ADDENDUM #1

Reference: Credit Union Improvements
Utah Valley University – Orem, Utah
DFCM Project No. 08308790

ADDENDUM - 1

Project: UVU Credit Union Improvements
DFCM Project Number: 08308790
Axis Project Number: 0809
To: Mike Ambre
From: Axis Architects
Date: April 3, 2009

3
SCALE: 3/4" = 1'-0" SE301

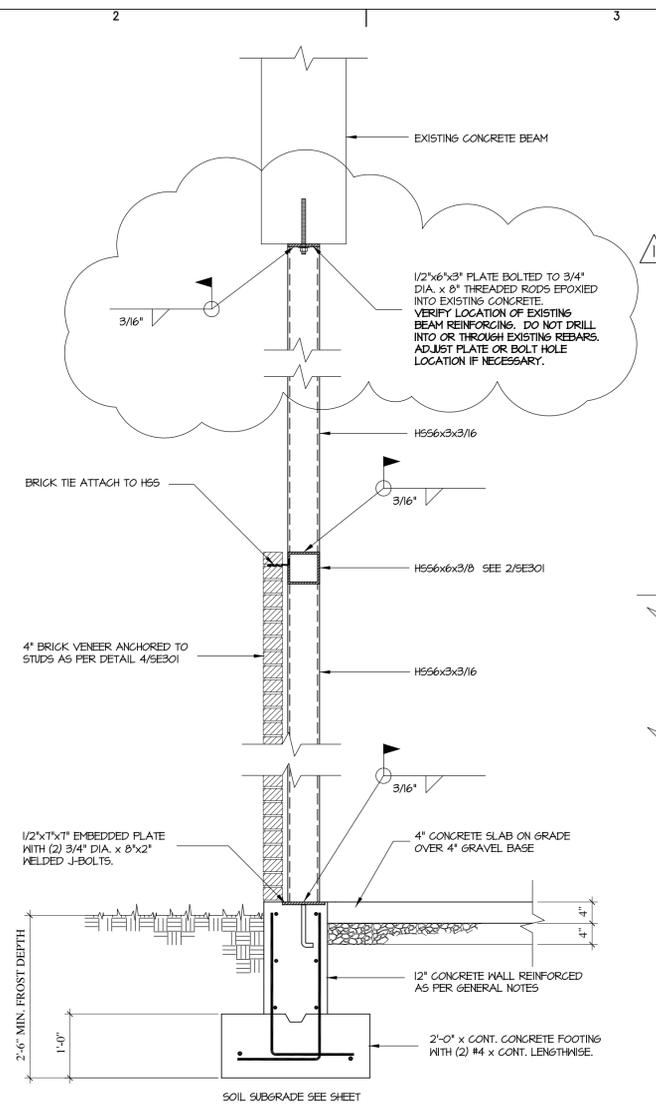
14. 3/SE301 detail has a top anchor plate for the steel post that will conflict with the window system. Is there a plan/detail for this?

- See the attached Revised Drawing Sheet SE301; Detail 3/SE301. The item that has changed is the attachment of the tube steel to the bottom of the concrete beam.
15. There is a concern for the attachment of the structural beam on the low end. It appears that there will only be 3" of beam to attach two ¾" bolts vertically to. This more than likely will be a problem. These beams have a huge amount of rebar in the bottom 6" and that close to the edge will very possibly cause a breakout of the concrete on the beam.
- The structural beam on the low end shall be attached where the concrete verticals occur at third points between the grids.
16. Sheet EG001 "Bidding Requirements" Note #1 notes prior approval before bidding. Is this just for substitutions of lights/equipment, or does this apply to Electrical contractors?
- This pertains to products. No prior approval requests were received.
